## Internal Letter

SUBJECT: SECONDARY CONTAINMENT REQUIREMENTS FOR THE WASTE SYSTEM EVAPORATOR PROJECT (394904)

## COOKING EVEL ELEVATION VIEW

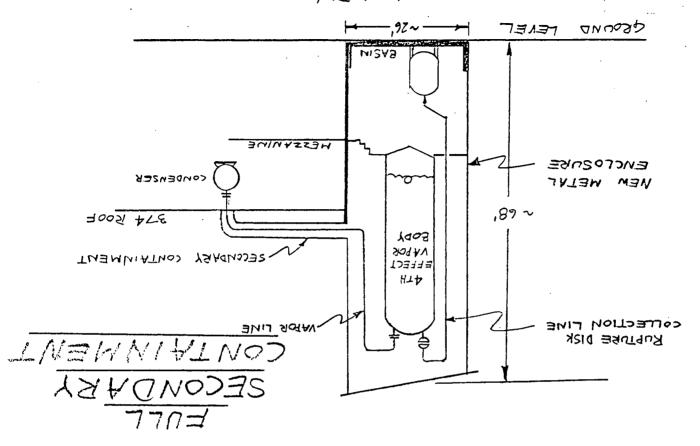
The only practical way to provide secondary containment for the vapor bodies and vapor lines would be to make the enclosure large enough to cover the vapor body and run the vapor lines inside a second pipe. Vapor lines range from 8 to 14 inch diameter pipe with about 3 inches of insulation. This would require a large secondary pipe. To make the metal enclosure enclose the entire vapor body would add significantly to the size of the structure and the cost of the project. The structure would extend above the 374 roof level about thirty feet and be about seventy feet tall (see sketch).

With this additional information, consider the containment philosophy that is appropriate for this project and respond as soon as possible. The philosophy will have a significant impact on the design and cost of the structure.
